ANALYSIS OF THE 25 YEAR PLAN FOR THE
PROPOSED CONSOLIDATED DELPARK/HUNTLY MINE

A REPORT TO THE
MINING AND MANAGEMENT PROGRAMME LIAISON GROUP

JULY 1986.

Report of a Working Group convened to consider the 25 year bauxite mine plan proposed by Alcoa for a combined Del Park/Huntly operation.

25 YEAR MINING
PROGRESSION
CLARK MINE 1986-2010

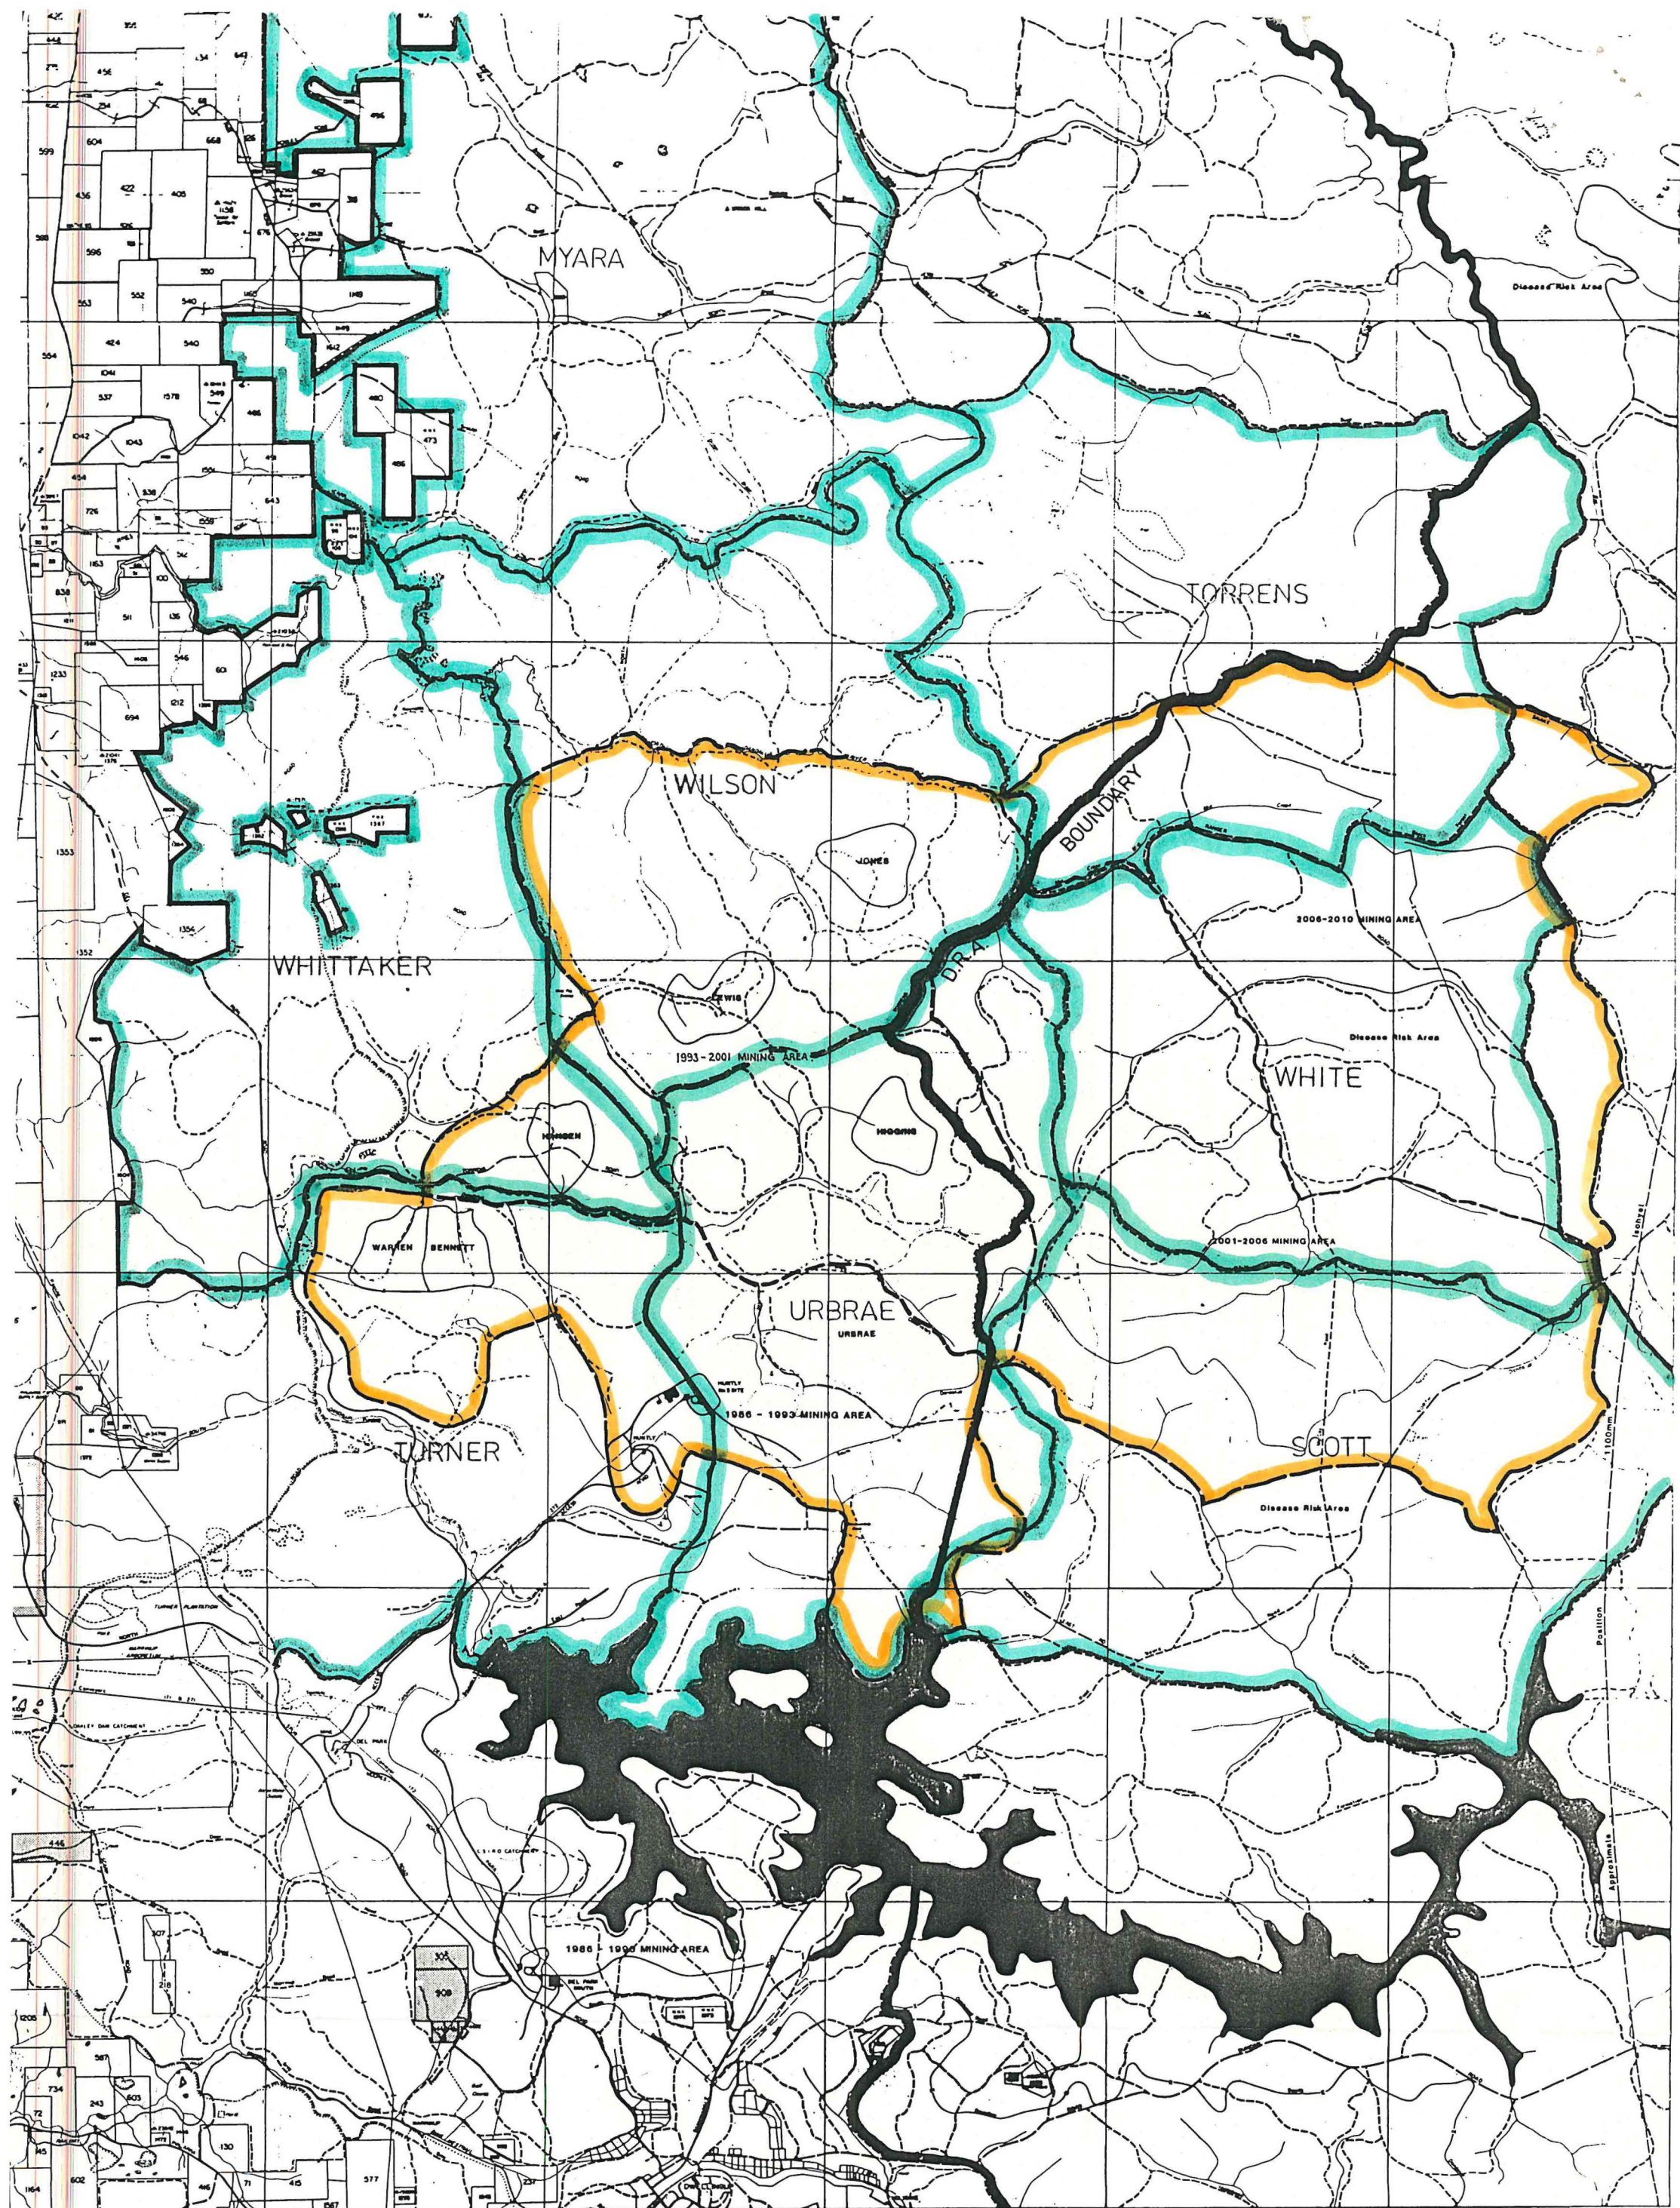
1. Bypassing marginal bauxite in Whittaker block is on balance an acceptable proposal (Section 4.1).
2. The proposed eastern boundary is acceptable. Guidelines should be adopted which adequately define the salt-sensitive boundary on the local and regional scale. Suggested guidelines in Appendix A provide scope for adjustment of the proposed boundary but this is appropriately done on the 5 year plan time scale (Section 4.2).

4. There is sufficient promise in new disease management strategies to approve in principle future mining within DRA, subject to the development and evaluation of new disease management systems proving satisfactory (Section 4.5, Land Use Plan).

5. There are significant benefits to be gained by proclaiming DRA status over much of the forest in the 0 - 15 year span of the proposed plan. However, this should be subject to detailed consideration of the boundary and clear specification of the purpose of the extension.
